DATE : 3/13/2018
FOR : FCO / Sales / DICD
FROM : Project Development
CC : Legal & Permits / IT / DICD / Finance / Design & Engineering / Marketing /
Accounting / Business Process / PD File
RE : Verdon Parc (VRP)
Updated Parking Availability plans

This is to inform your good office that we are releasing the updated parking availability plans for the buildings Belvedere, Trevans and Maurin.

BELVEDERE
UPPER GROUND PARKING LEVEL

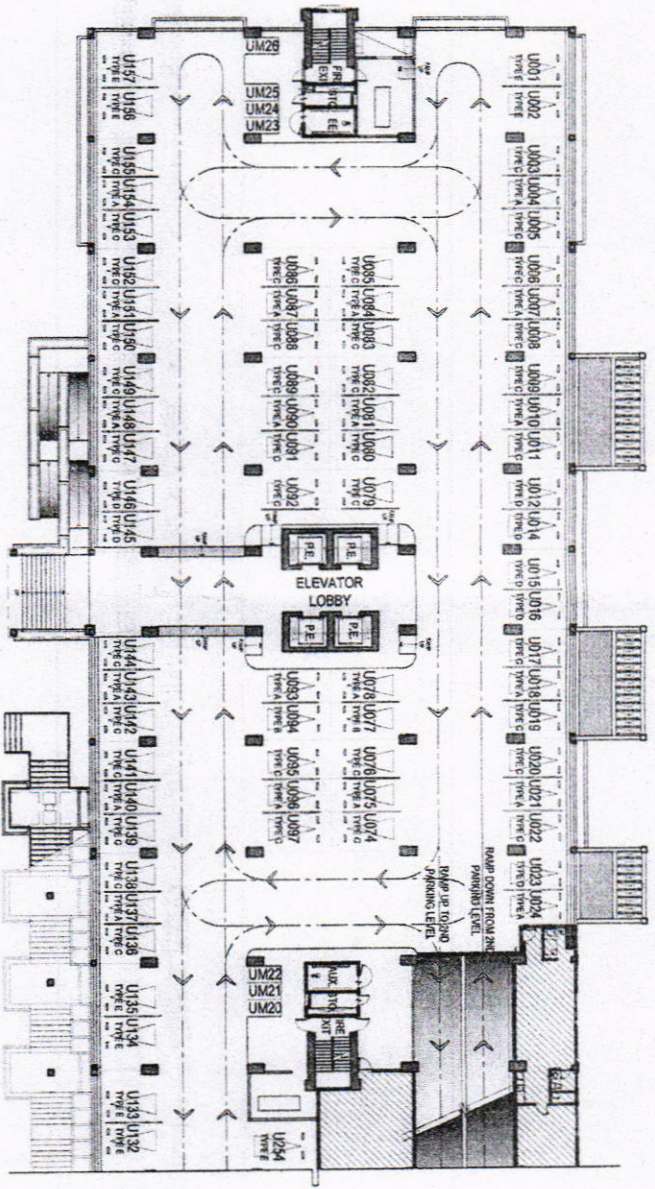
Kindly take note that the following parking slot and motorcycle parking are deleted

Building	Type	Parking slot no.	Effective plans
Maurin	Single Parking	L240	LG – March 5, 2018
Belvedere	Motorcycle Parking	UM01	LG & 2 nd – November 20, 2017 UG – March 5, 2018
		UM02	
		UM03	
Trevans	Motorcycle Parking	UM14	LG & 2 nd – November 20, 2017 UG – March 5, 2018
		UM15	
		UM16	
		UM17	
		UM18	
		UM19
